From: Haupt, Michael L. [mhaupt@nd.gov]
Sent: Monday, June 20, 2011 10:40 AM
To: William McCarthy
Cc: Katie Schmidt
Subject: RE: BPE Garden Creek Pipeline-Project Review Request for Presence of School Trust and State Mineral Trust Lands

Subject: BPE Garden Creek Pipeline-Project Review Request for Presence of School Trust and State Mineral Trust Lands

16-T147-R104

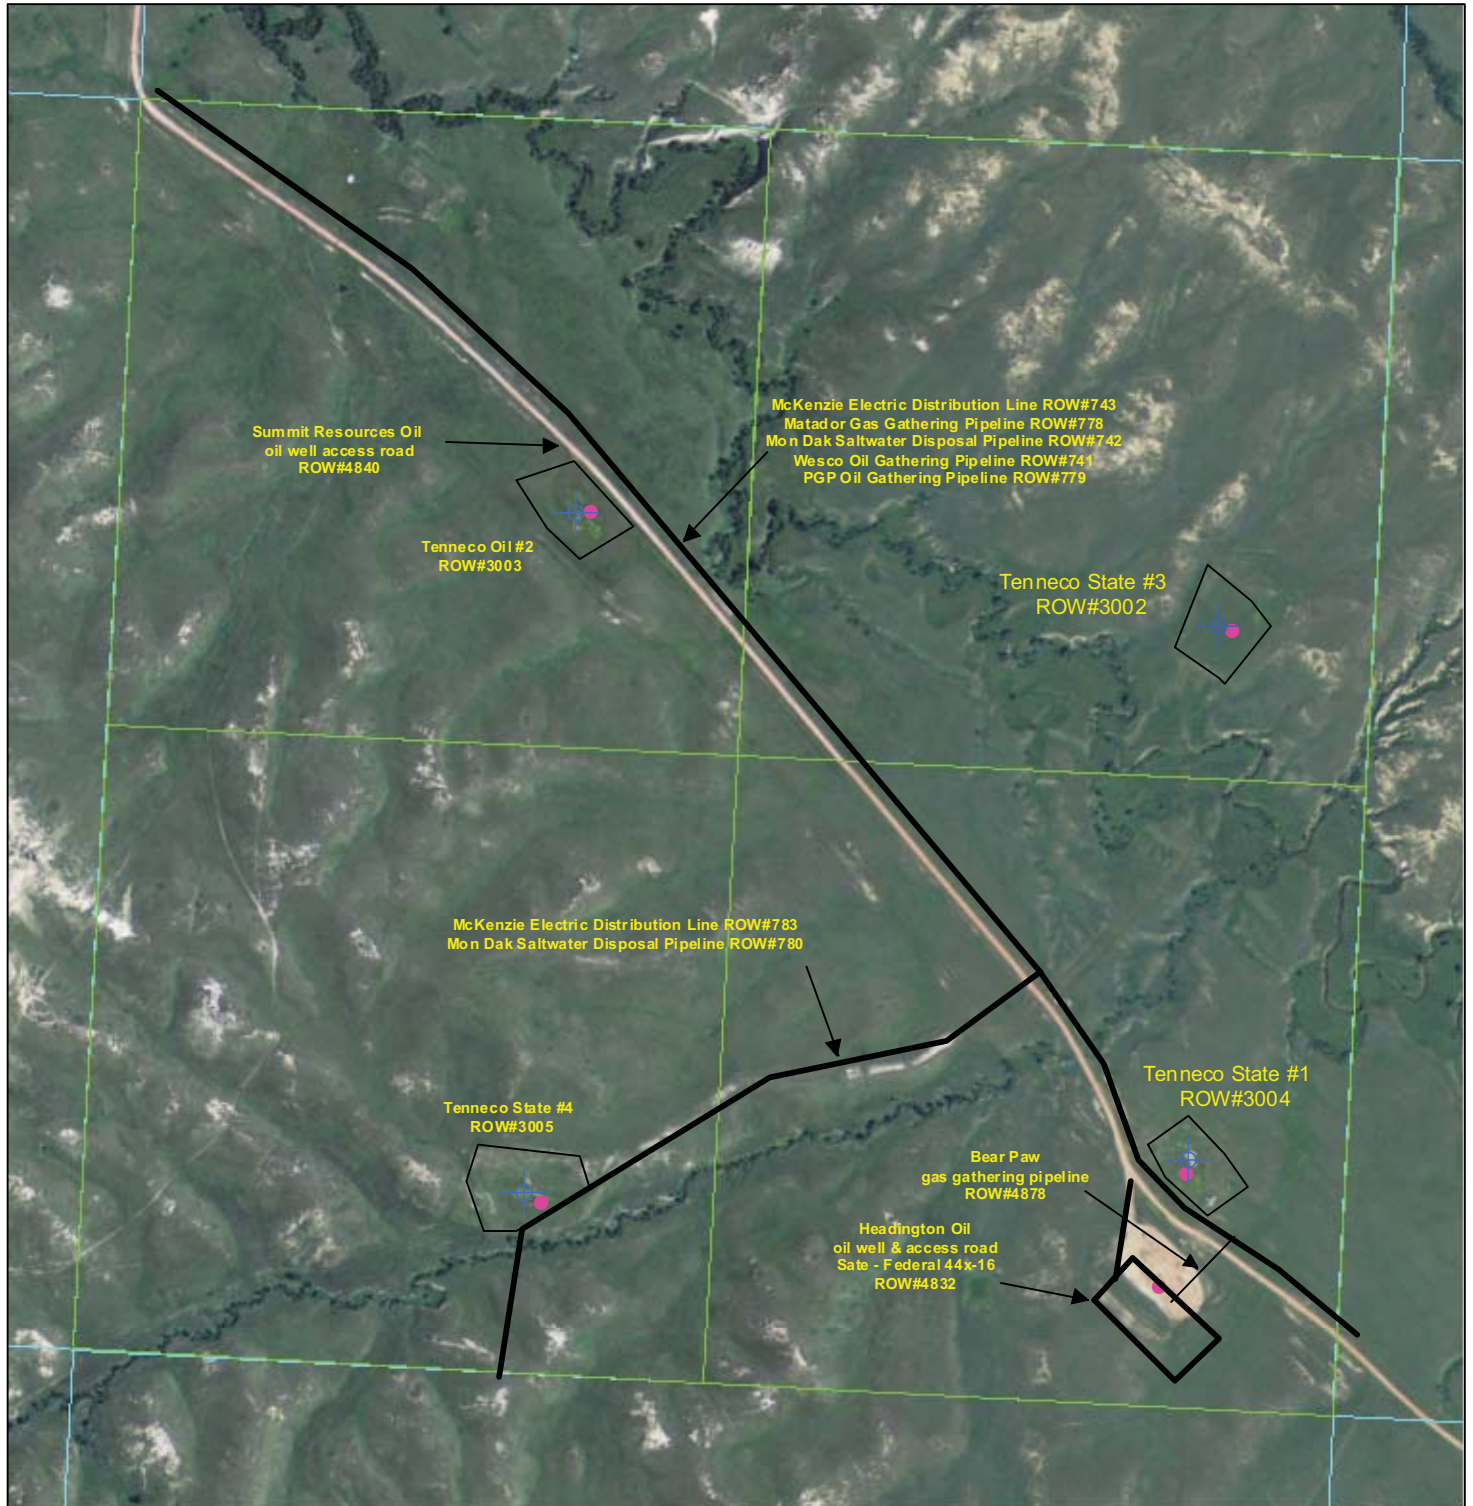
147-104-16 N2, SE4: There is an existing suitable pipeline corridor adjacent to and parallel with the oil well access road that runs southeast to northwest across this tract.

36-T148-R105

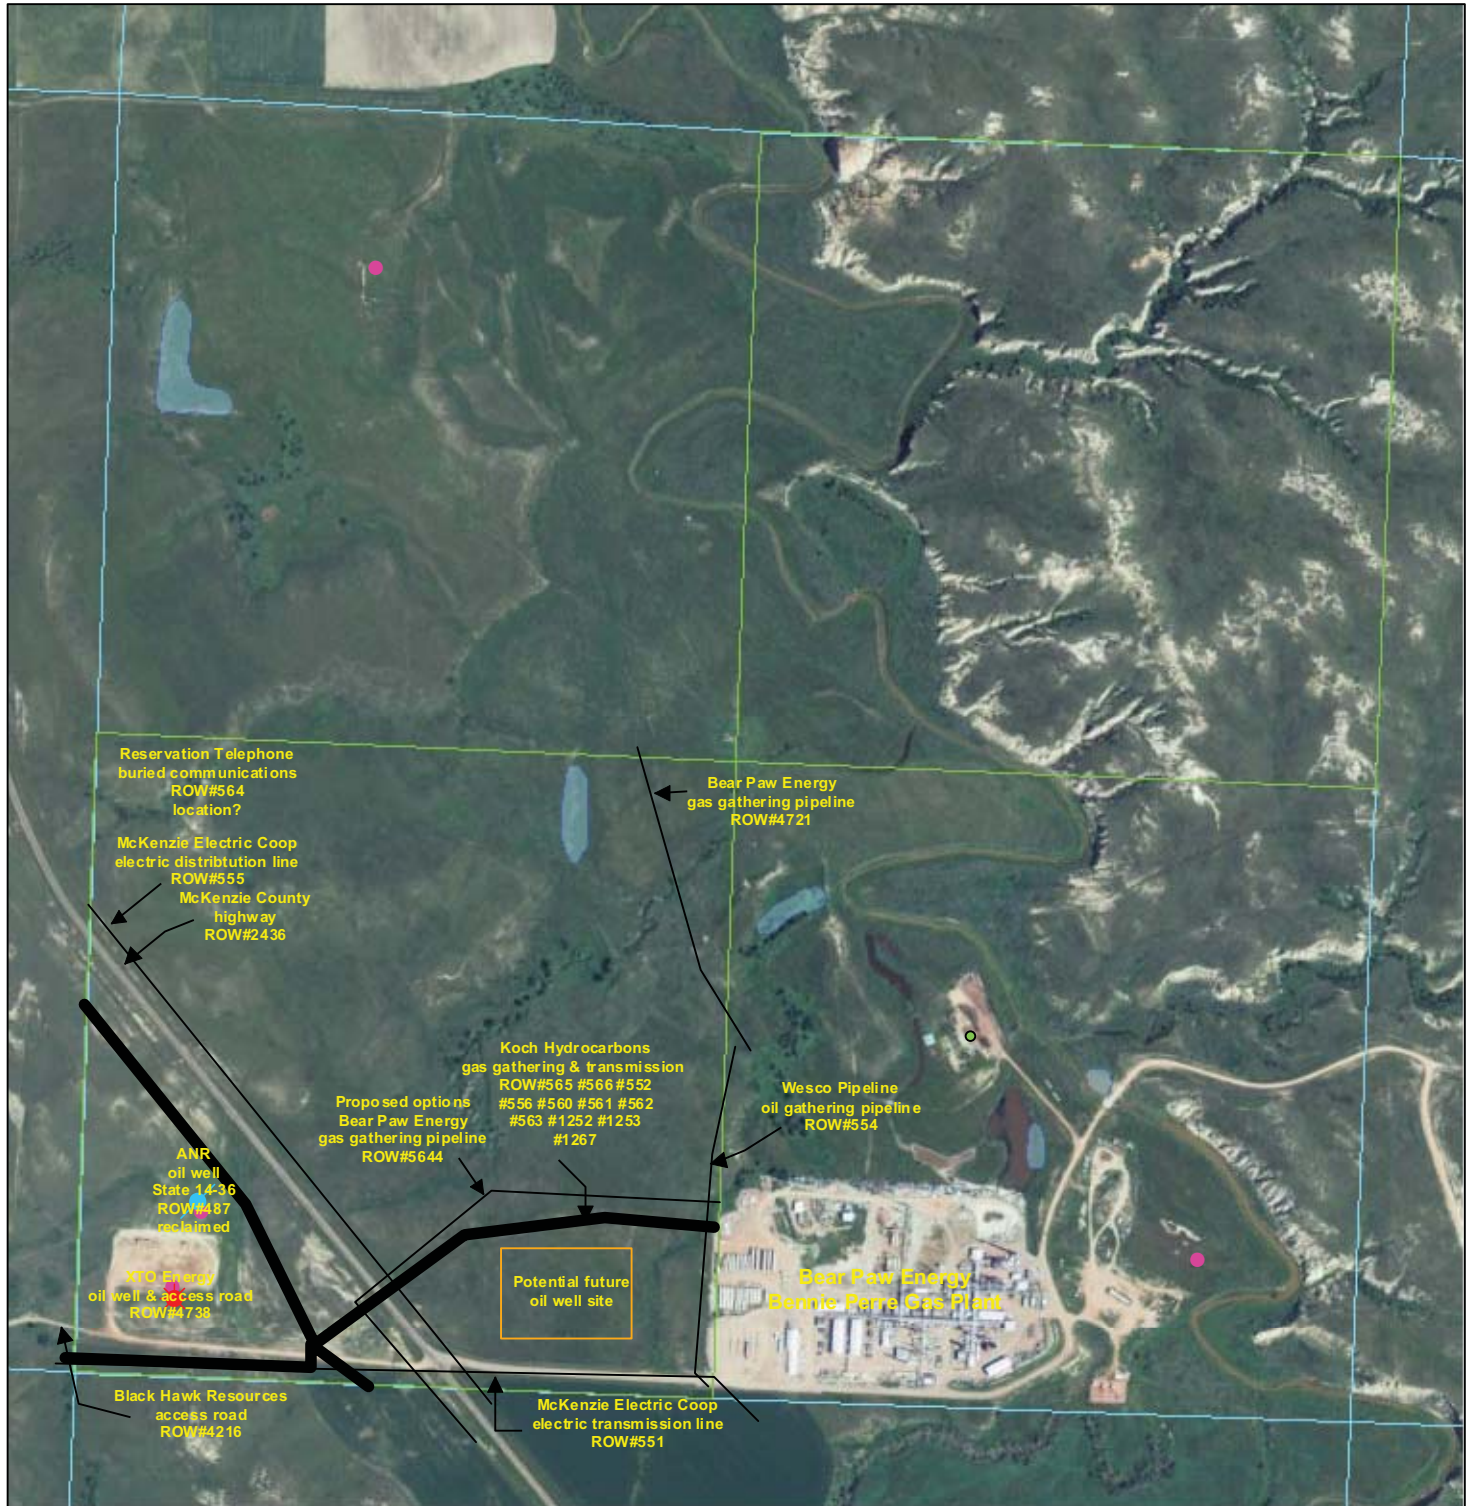
Good morning! Based on the info you sent, the only school trust land within the proposed Garden Creek Pipeline project appears to be in the SW4 36-148-105 McKenzie County. As shown on the attached aerial photo, there is an area off limits to the proposed pipeline – potential future oil well sites - that we cannot allow the proposed pipeline to cross. If Bear Paw can find a way around this site please submit an on line application on our web site at <http://www.land.nd.gov/surface/row/> for consideration. Let me know if you have questions. Thanks.

148-105-36 SW4: Very limited room for additional pipelines. Only potential would be very close to and parallel to the highway on this tract.

Thanks, we will not be installing any new pipe in that tract we will be in the section immediately west of this location. Please ignore the black dot and dash line that is an existing pipeline, the proposed line is depicted in yellow. Please see attached.

Good morning, thank-you for the response to our consultation. Please note that the current routing for the Garden Creek NGL Pipeline avoids the area of concern that you indicated. Please see the attached map – the yellow line depicts the proposed route of Garden Creek NGL Pipeline while the black dot and dash line depicts existing pipeline(s). The routing will be immediately west of the XTO well and access road.

16-T150-R99

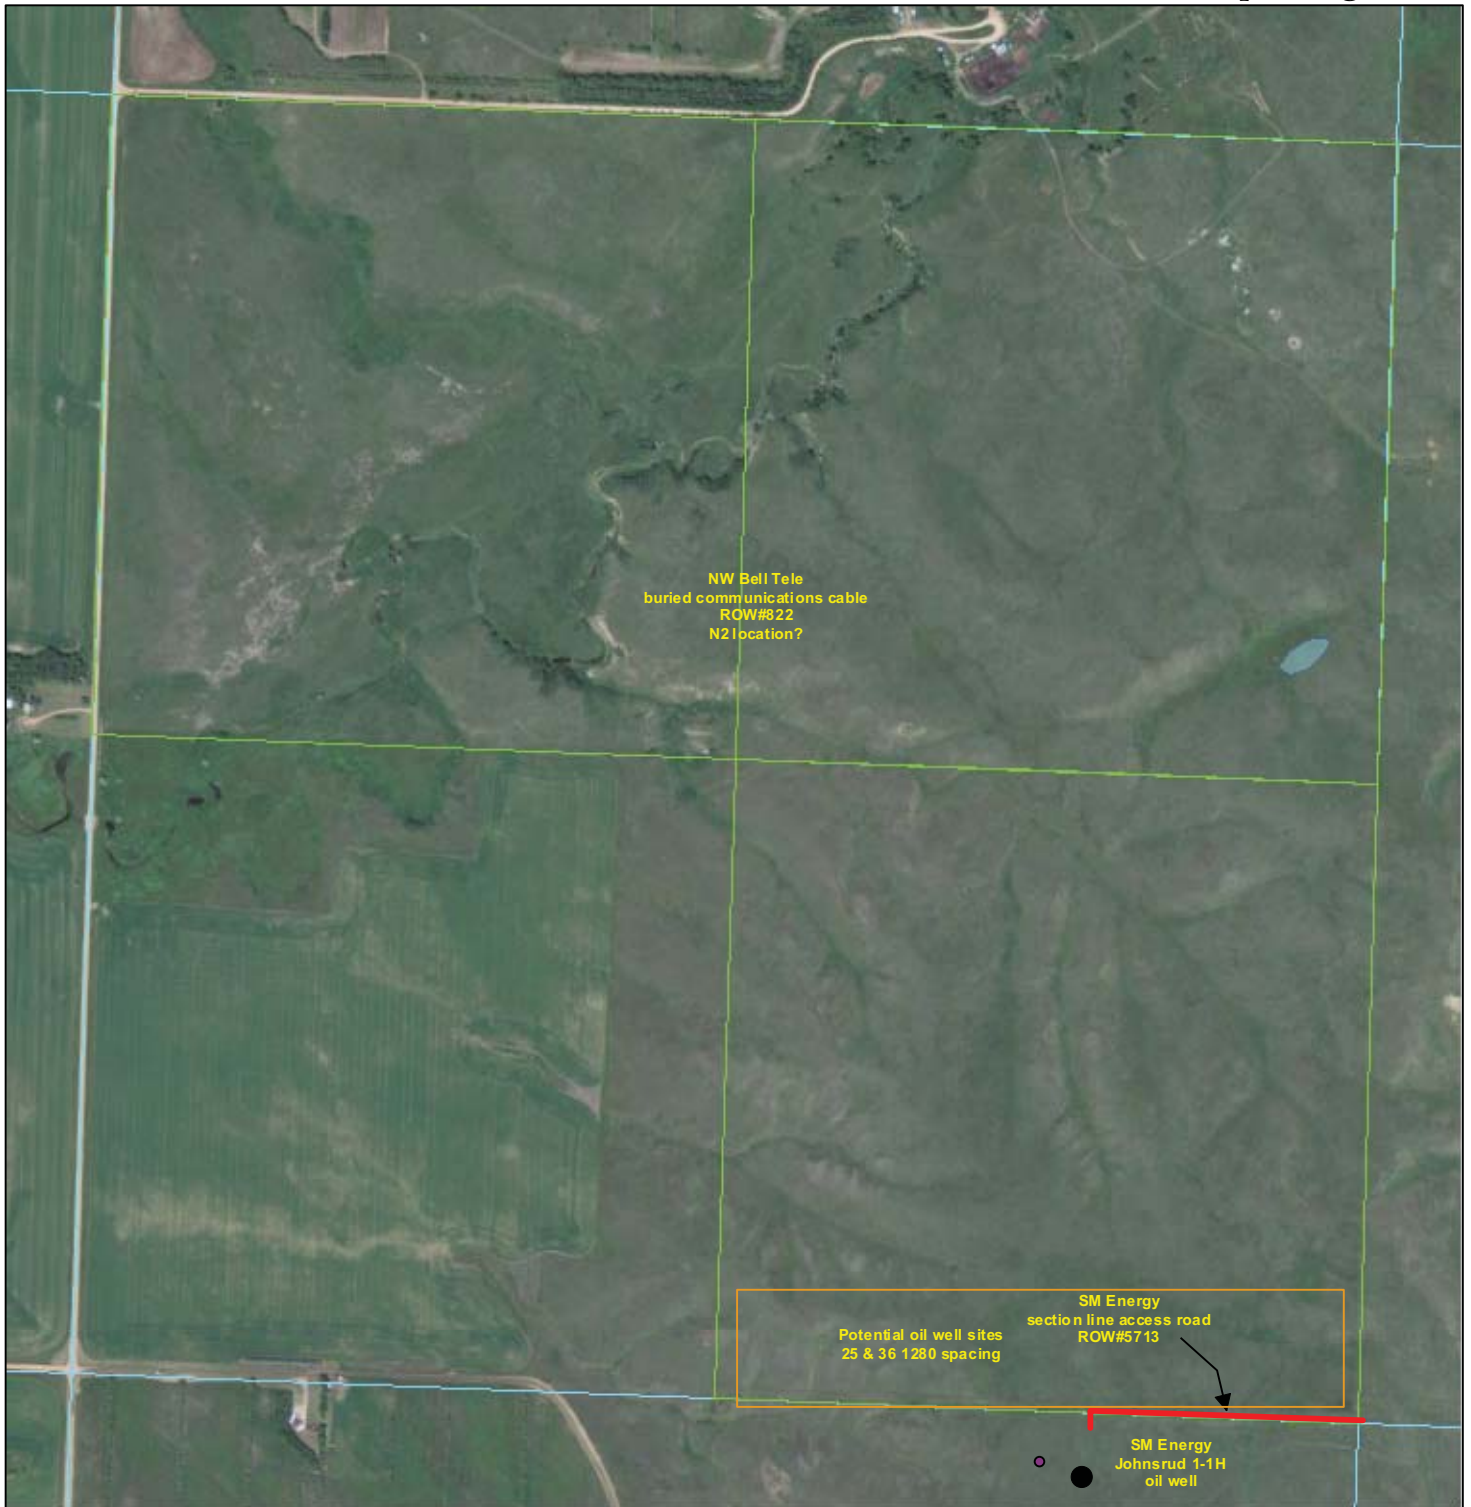
150-99-16 N2: 640 acres oil spacing unit which means potential well sites around the perimeter of the section. Potential pipeline corridor on the east-west half line but an onsite inspection to determine suitability is required.
